## Public Comments:

### A Structural Reevaluation of the Collapse of World Trade Center 7 – Draft Report

Hulsey, J.L., Quan, Z., and Xiao, F.

Department of Civil and Environmental Engineering, College of Engineering and Mines, Institute of Northern Engineering, University of Alaska Fairbanks, Fairbanks, AK  
INE Report 18.17

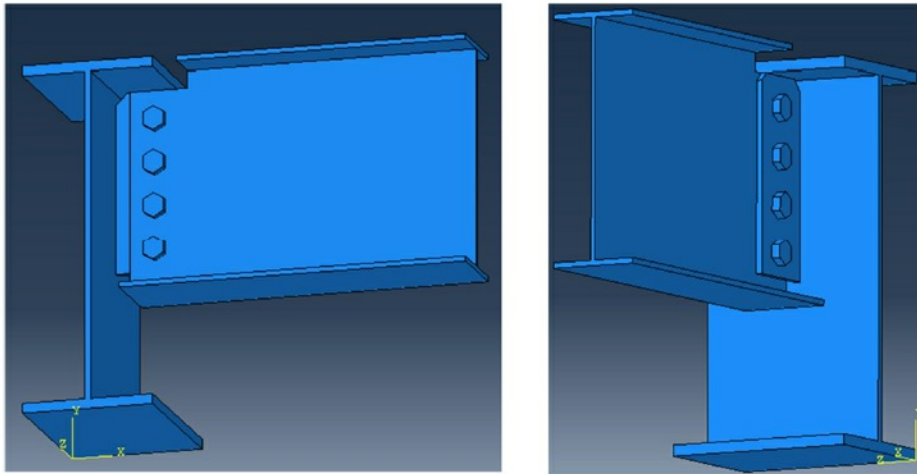
(3) page 55 - reference to Figures 2.39 and 2.40 omitted, unnumbered figures appear duplicated

Figure 4.23: Velocity comparison between Chandler measurement (green plotted line) and UAF simulation (red plotted line). Bold green trend line illustrates free fall.

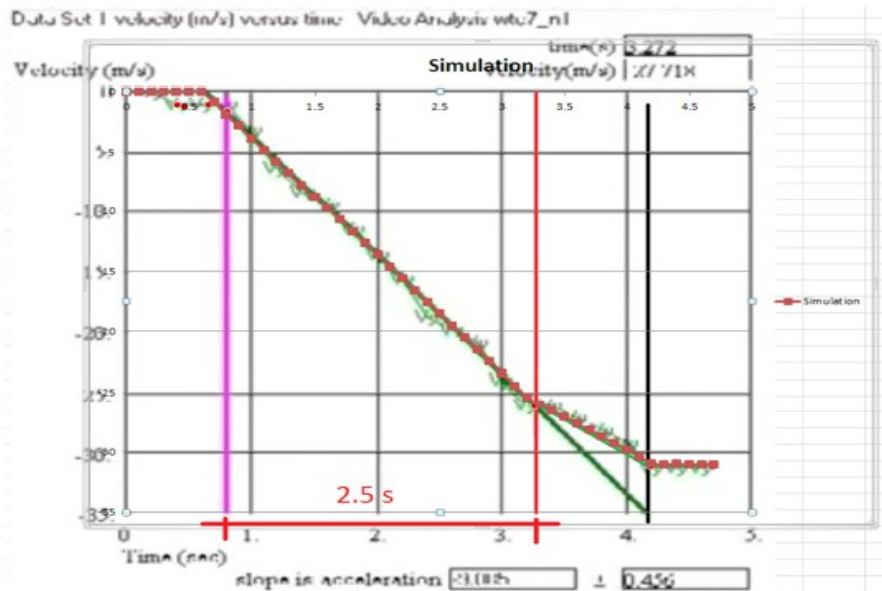
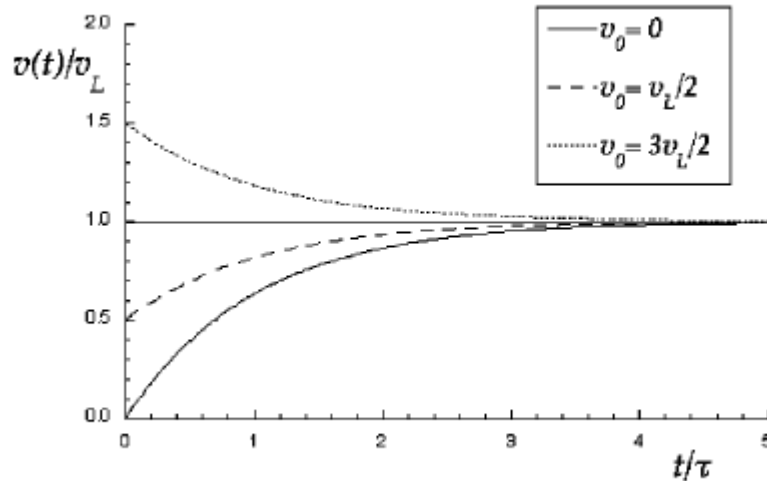
Moreover the UAF report says: “Bold green trend line illustrates free fall”.

This is not accurate. Bold green trend line illustrates a free fall in the vacuum, so it is not realistic. Falling speed of WTC7 reached a velocity greater than 30m/s. At such speed it is not correct to ignore the presence of air, so velocity vs. time should not be linear. Free fall in the air must take into account a resistant force depending on the speed and which increases with speed. As a consequence, in a real free fall, velocity must tend asymptotically to the limit velocity  $v_L$  according to the following picture.

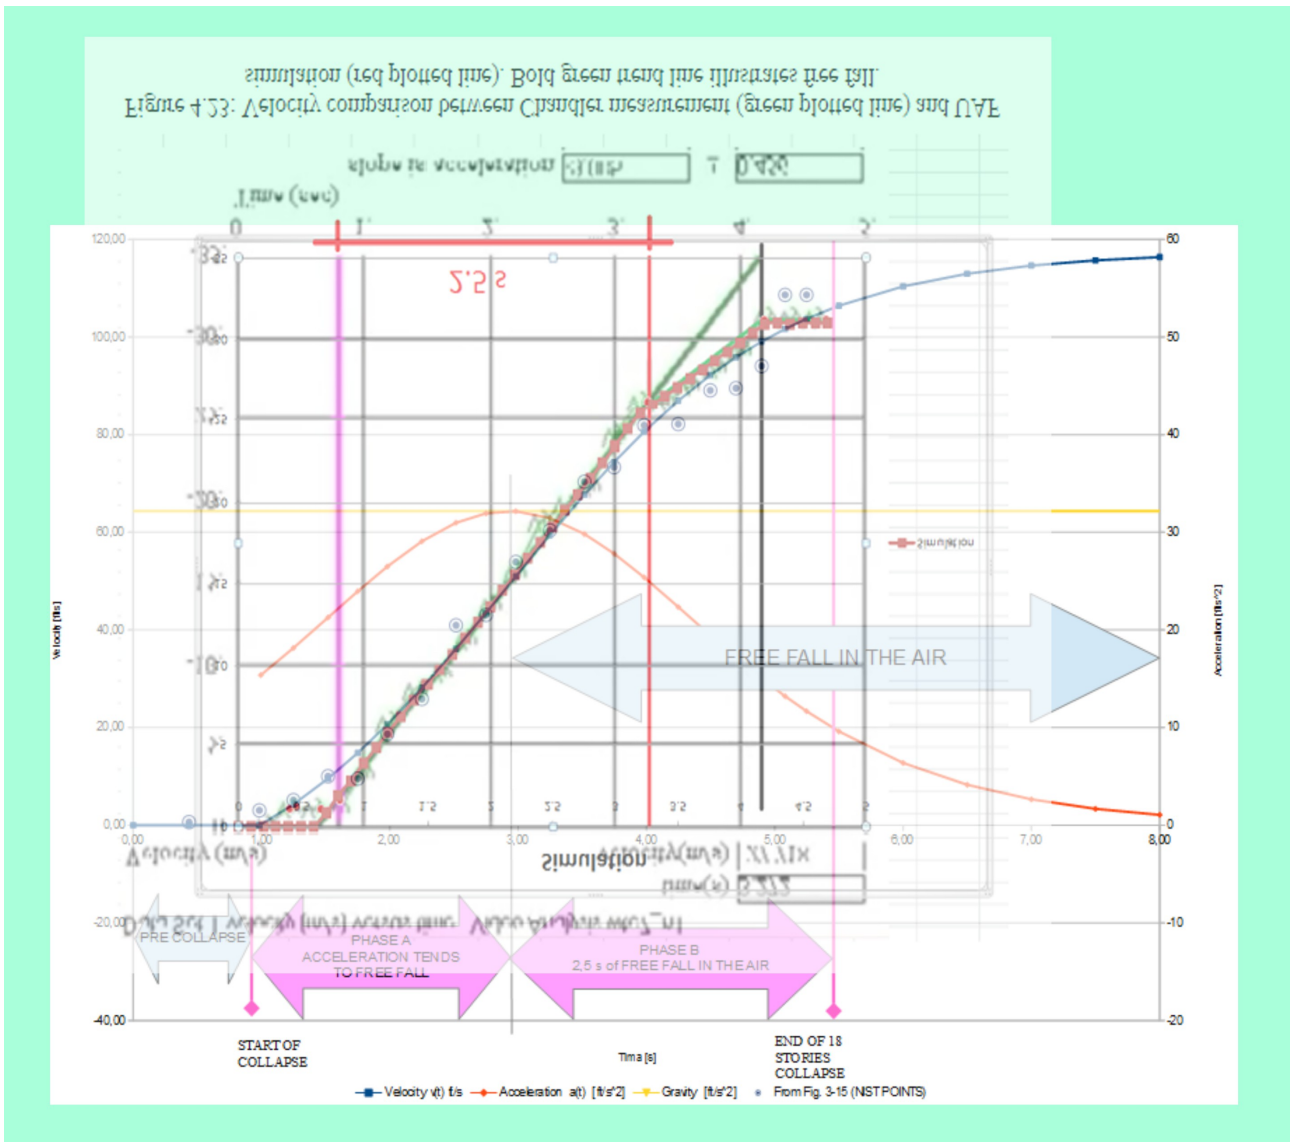
In the following there is an overlap between presious figure and UAF report Fig.4.23:

As you can see the function which interpolate NIST data set is extremely similar to both UAF simulation and David Chandler measurement.
